Allies & Ross Management and Development Corporation

IFB #2022-39

Plumbing Construction for the Manchester Redevelopment

ADDENDUM NO. #2

SD3 Supplemental Drawing No.3 CMU Foundation w/ Single French Drain + Sump Pump
SCALE: 3/4" = 1'-0"

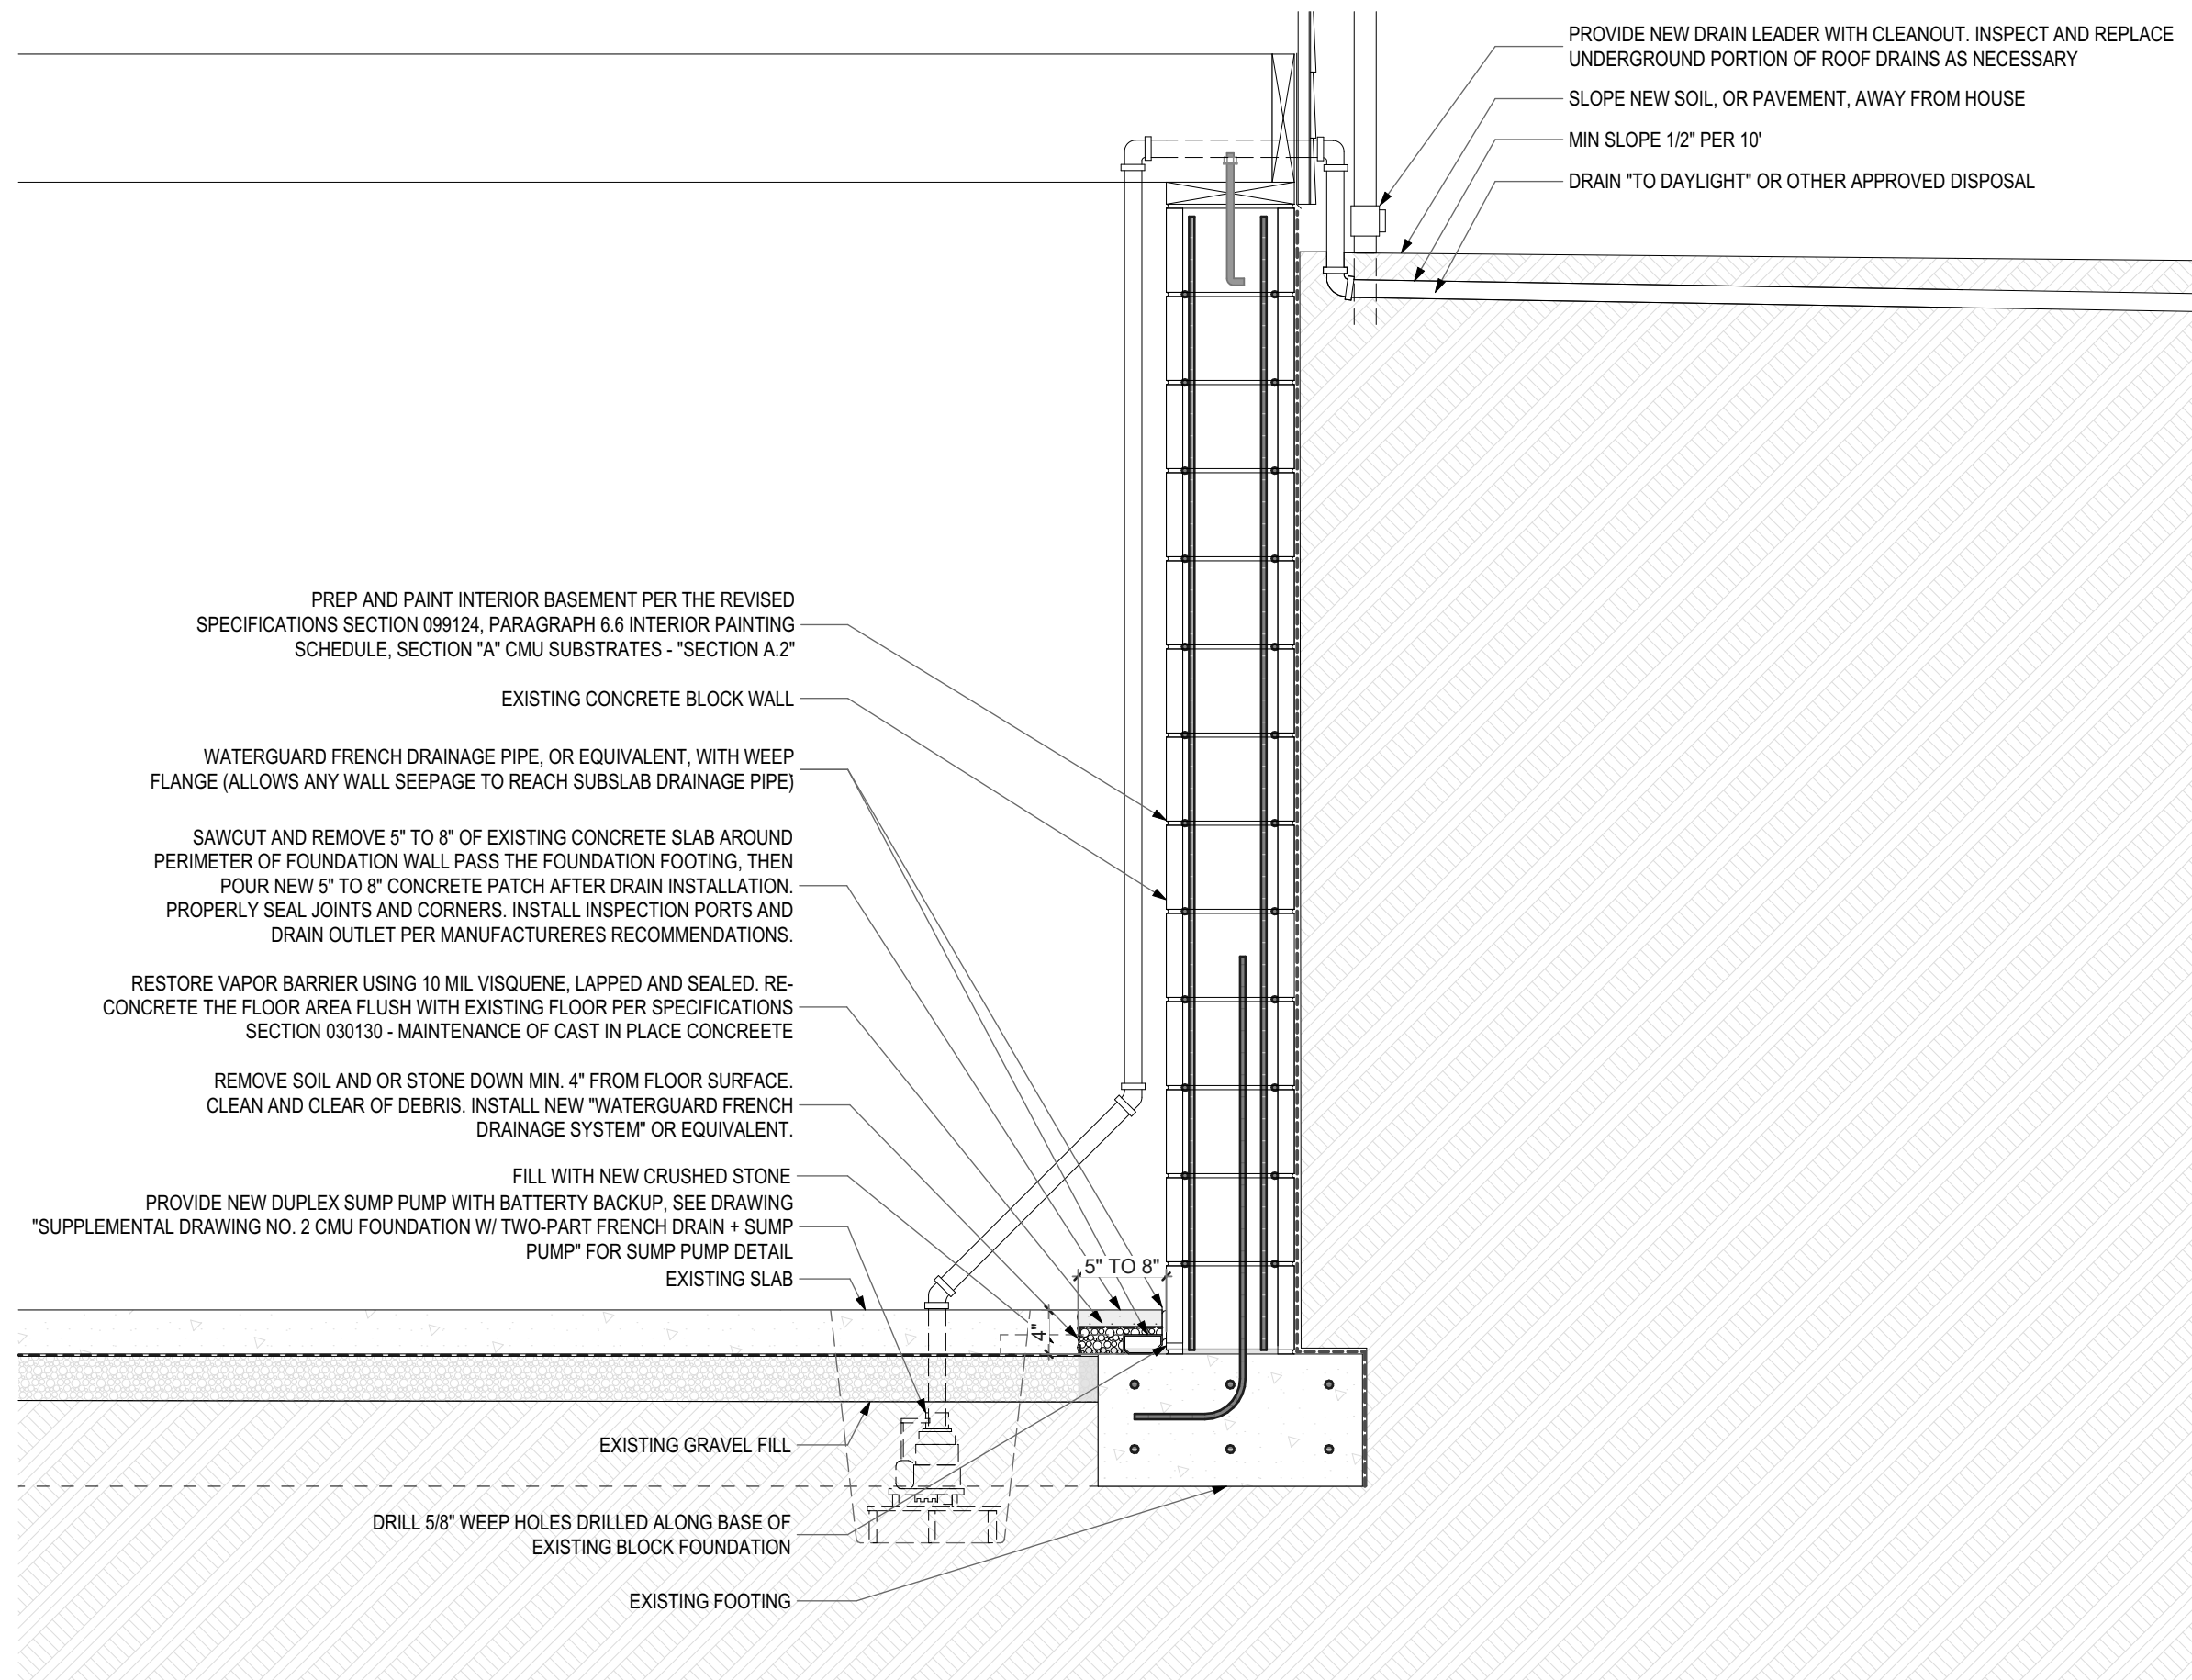
1. Supplemental Drawing No.2 CMU Foundation w/ Two-Part French Drain + Sump Pump
2. Supplemental Drawing No.3 CMU Foundation w/ Single French Drain + Sump Pump
